File No. **29855-D2**      11. County: FI      Basin: **ARKANSAS RIVER**      Stream:      Formation Code:      Special Use:

## DWR FIELD OFFICE APPLICATION FOR APPROVAL TO CHANGE THE PLACE OF USE AND/OR THE POINT OF DIVERSION

**SUMMARY ORDER APPROVING APPLICATION FOR CHANGE AND IMPOSING CONDITIONS**

RE: Applications for Change in Place of Use  
Water Right, File Nos. 16157, 19820 D8, 20890, 22576 D2, 22576 D3, 22576 DA, 22576  
DB, 22577 D1, 22578 D2, 24050, 28620, 28621 D2, 29855 D1, 29855 D2 & 30157

**CHANGE IN PLACE OF USE WATER RIGHT, FILE NOS. 16157;  
 19820-D8; 20890; 22576-D2; 22576-D3; 22576-DA; 22576-DB;  
 22577-D1; 22578-D2; 24050; 28620; 29855-D1; 29855-D2 & 30157**

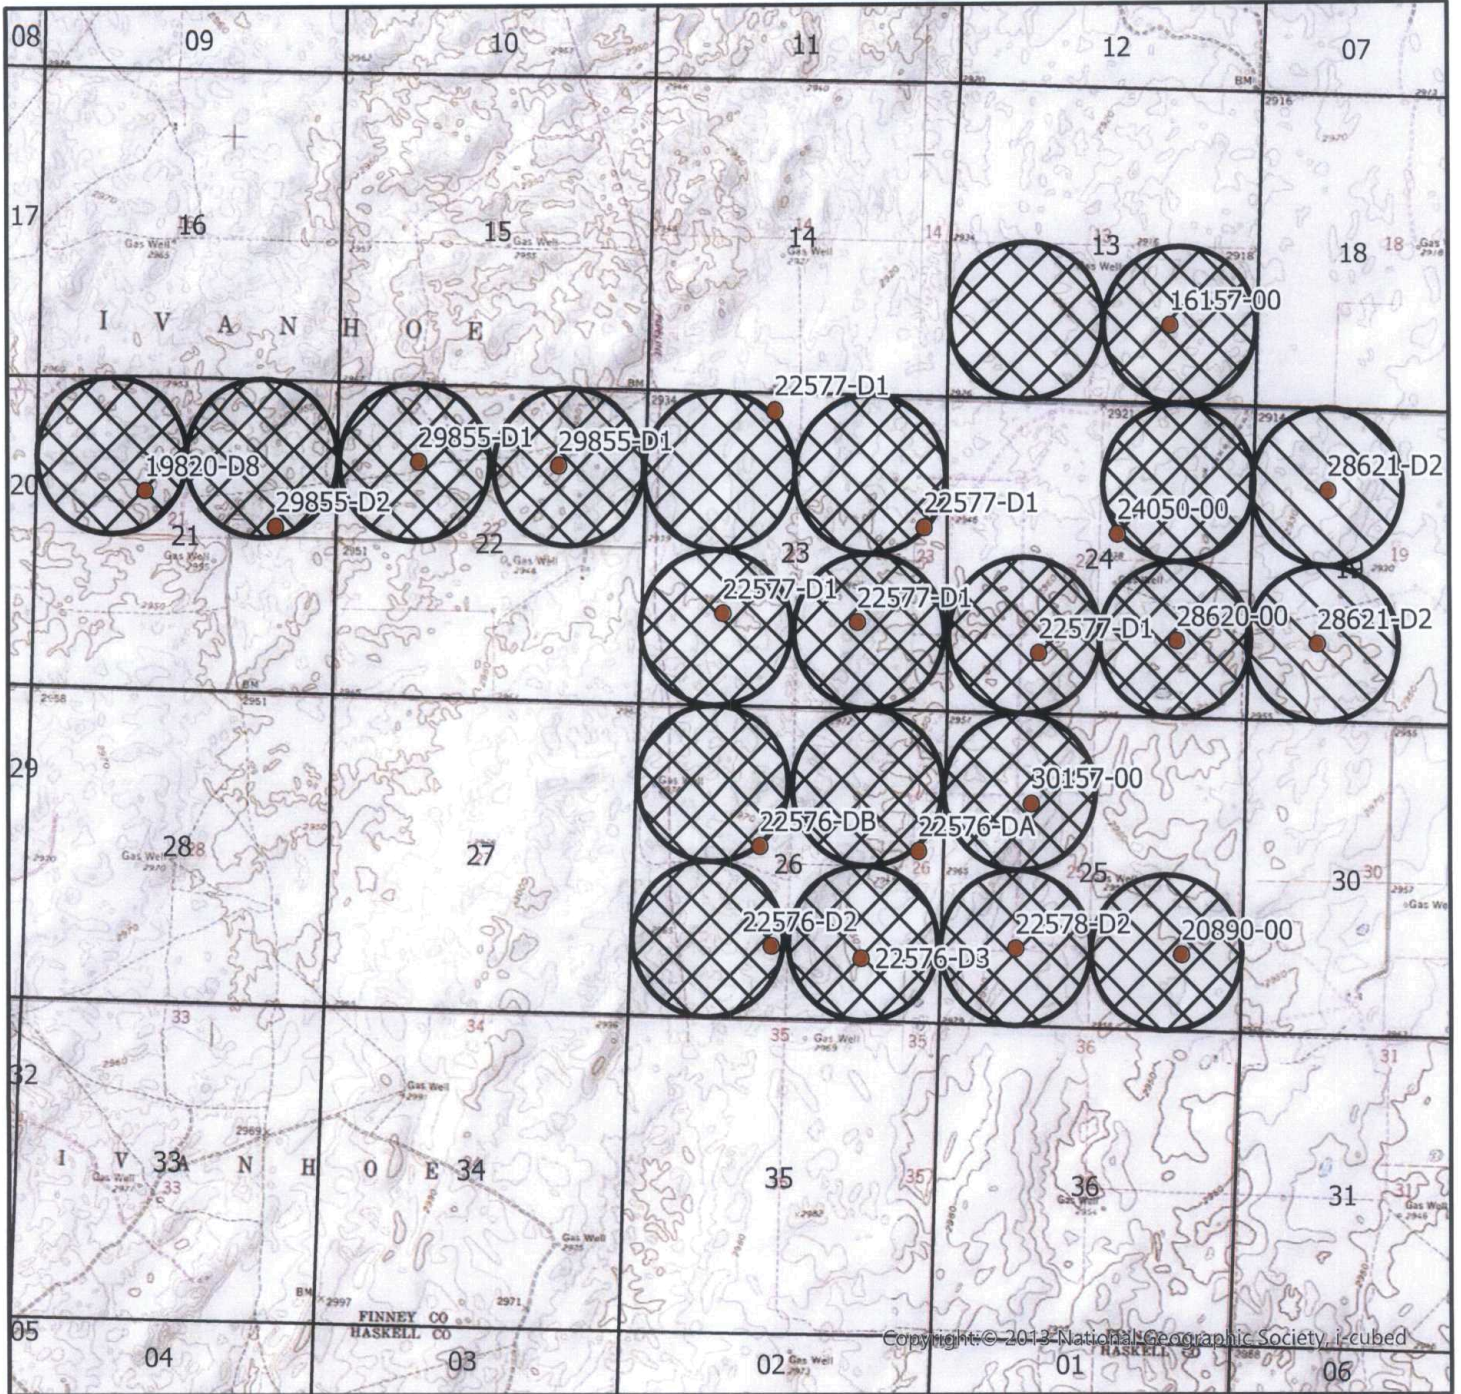
We have reviewed the applications for the above referenced water rights. The proposals are not in conflict with the Management Program of the Southwest Kansas Groundwater Management District No. 3 (GMD3). The proposed change in place of use will make a complete overlap in currently authorized place of use in accordance with K.A.R. 5-5-11(b). It is therefore recommended that the applications be approved at this time.

Is Proposed PU overlapping existing WRs? Bringing in 28621D2 acres to overlap with the rest that are already completely overlapped.

**Currently the land and wells under 28621D2 stand alone. The proposed change will now overlap the PU with the other water rights for a complete overlap. No new acres are being proposed that are not currently authorized by a water right.**

Recommendation: After review of all available information, it appears current area rules are met. Staff therefore recommends approval of the applications.
